EXISTING CONDITIONS  
OF A REPLAT LOT 1, VILLAGE DRIVE TOWNHOMES  
LOCATED IN THE SW ¼ OF SECTION 27, TOWNSHIP 6 NORTH, RANGE 84  
WEST OF THE 6TH P.M., STEAMBOAT SPRINGS, ROUTT COUNTY,  
COLORADO

INT	CFB	
REVISIONS	ADDENDUM #1 RE-ISSUE	
No.	DATE	7/11/25

**LOT 1  
VILLAGE DRIVE  
SUBDIVISION**

**SITE PLAN &  
REVISION  
EXHIBIT**

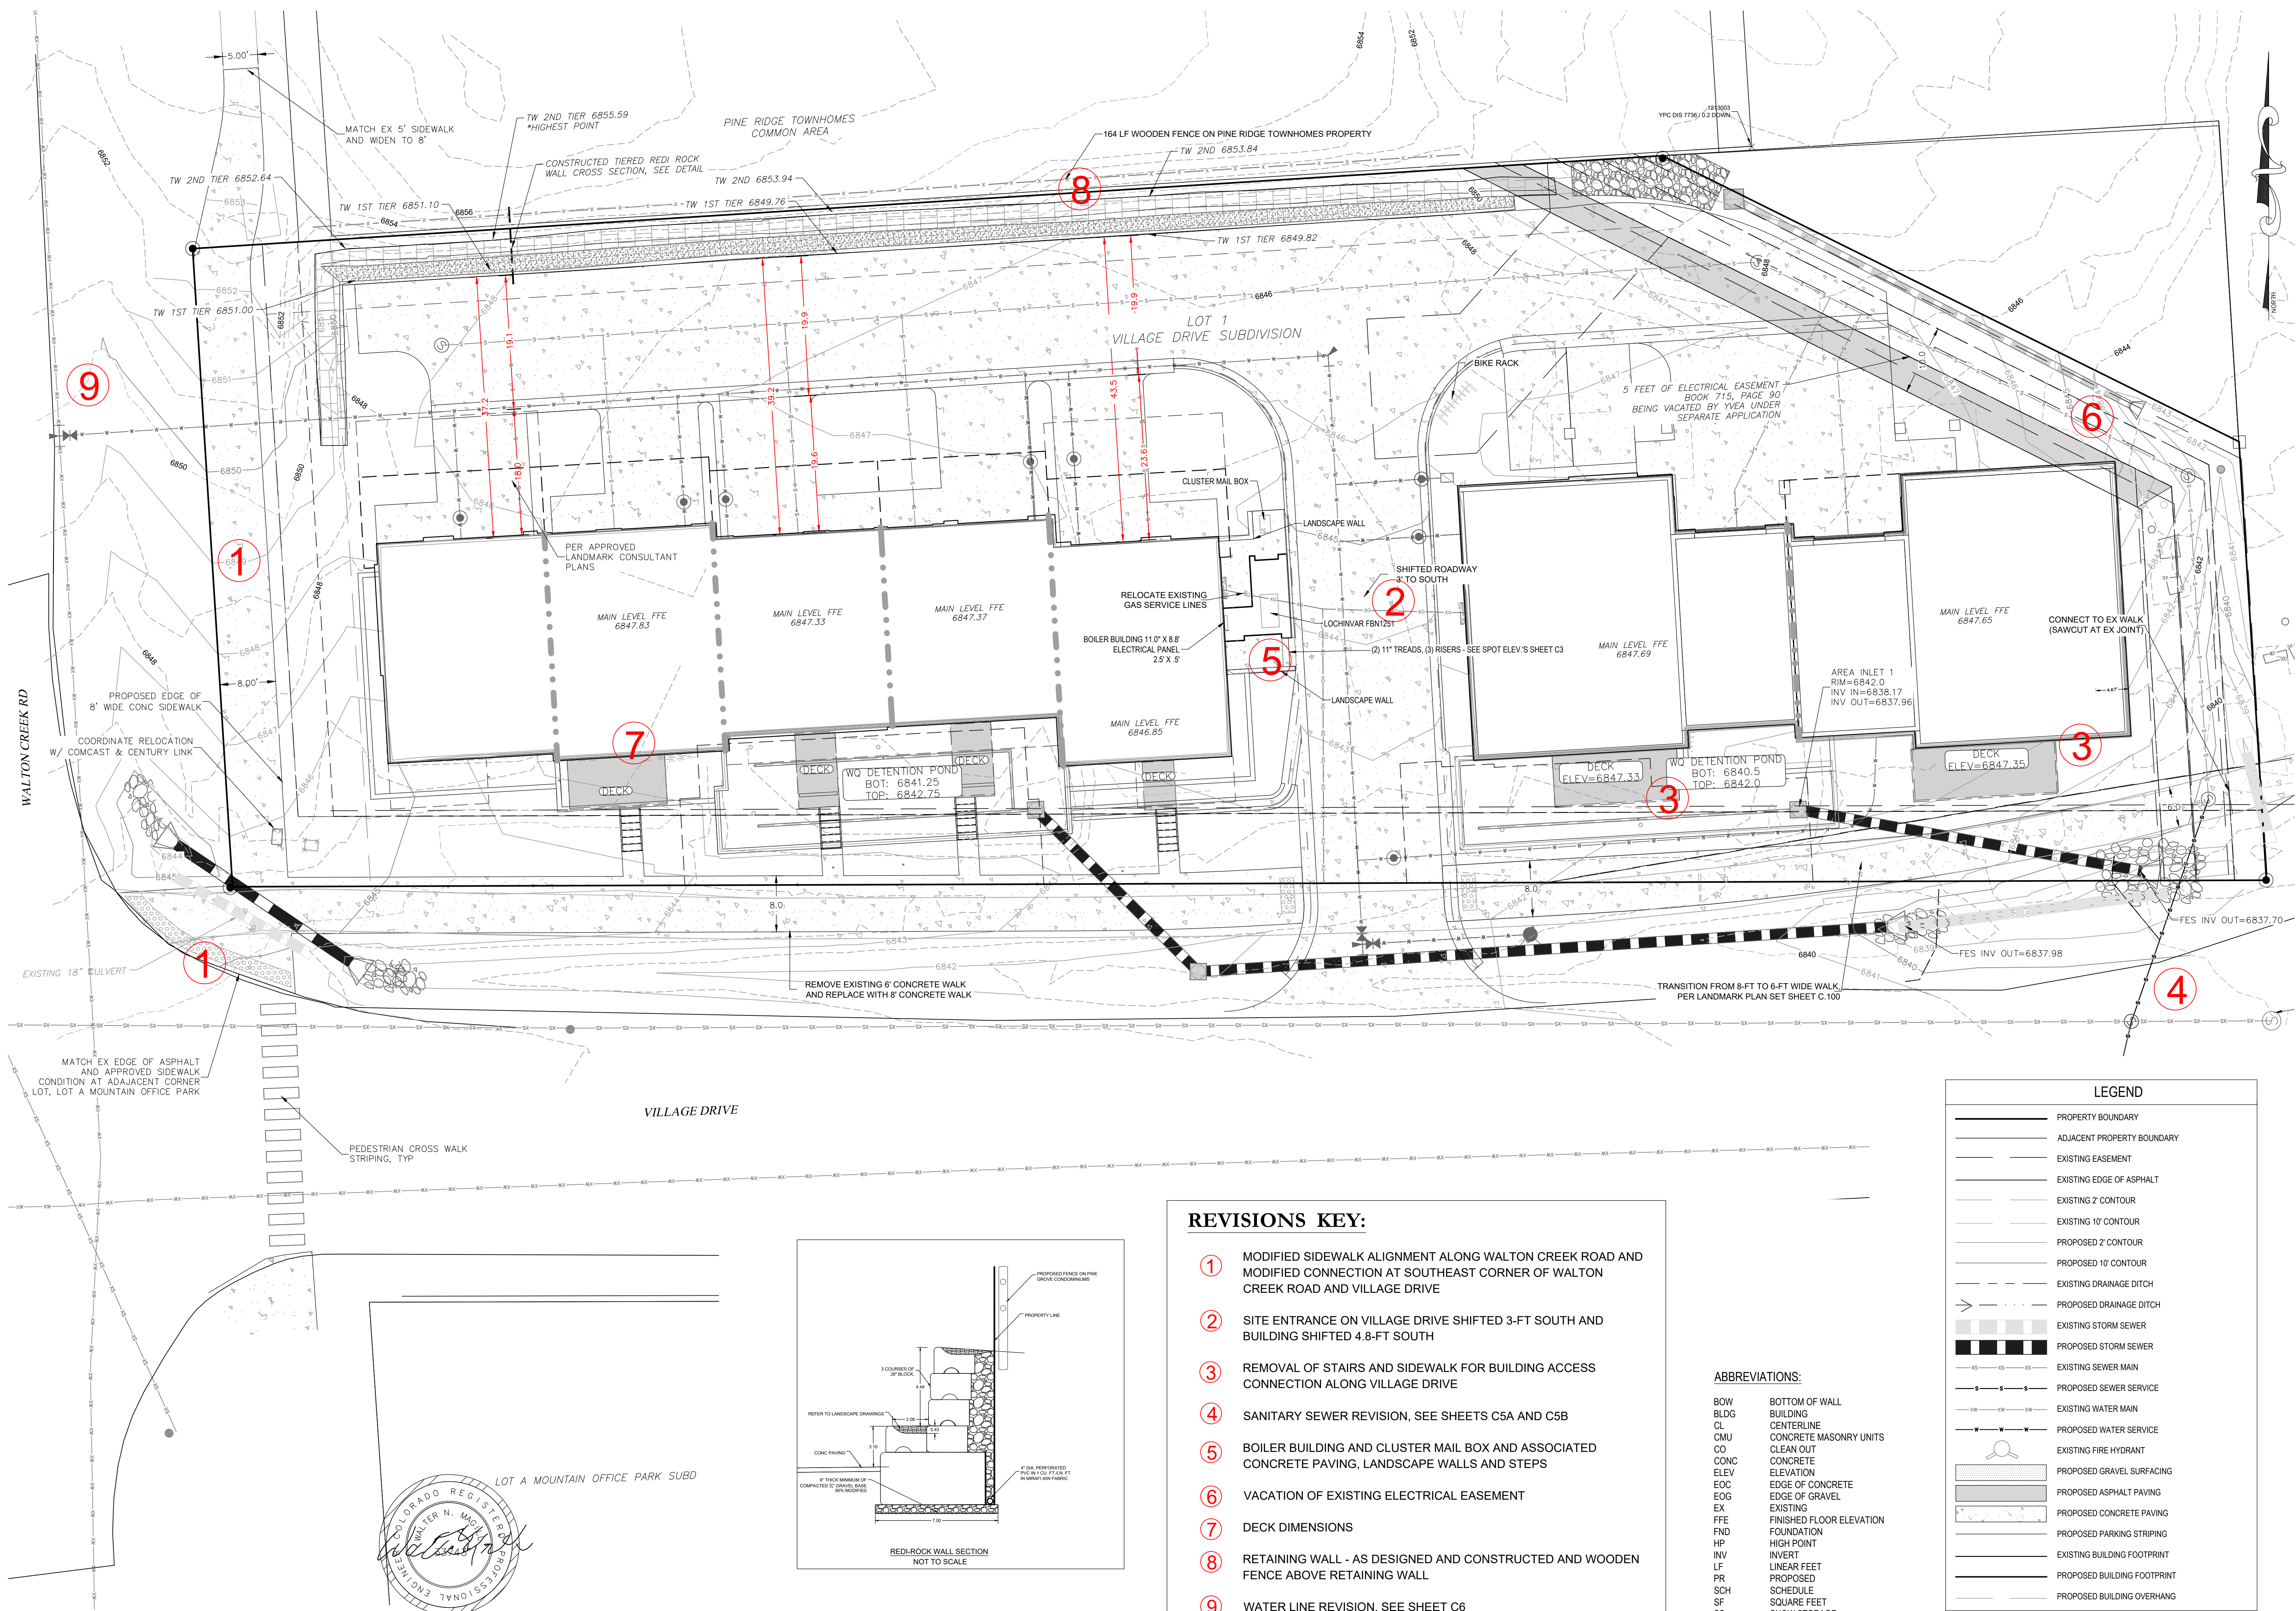
- REVISIONS KEY:**
- ① MODIFIED SIDEWALK ALIGNMENT ALONG WALTON CREEK ROAD AND MODIFIED CONNECTION AT SOUTHEAST CORNER OF WALTON CREEK ROAD AND VILLAGE DRIVE
  - ② SITE ENTRANCE ON VILLAGE DRIVE SHIFTED 3-FT SOUTH AND BUILDING SHIFTED 4.8-FT SOUTH
  - ③ REMOVAL OF STAIRS AND SIDEWALK FOR BUILDING ACCESS CONNECTION ALONG VILLAGE DRIVE
  - ④ SANITARY SEWER REVISION, SEE SHEETS C5A AND C5B
  - ⑤ BOILER BUILDING AND CLUSTER MAIL BOX AND ASSOCIATED CONCRETE PAVING, LANDSCAPE WALLS AND STEPS
  - ⑥ VACATION OF EXISTING ELECTRICAL EASEMENT
  - ⑦ DECK DIMENSIONS
  - ⑧ RETAINING WALL - AS DESIGNED AND CONSTRUCTED AND WOODEN FENCE ABOVE RETAINING WALL
  - ⑨ WATER LINE REVISION, SEE SHEET C6
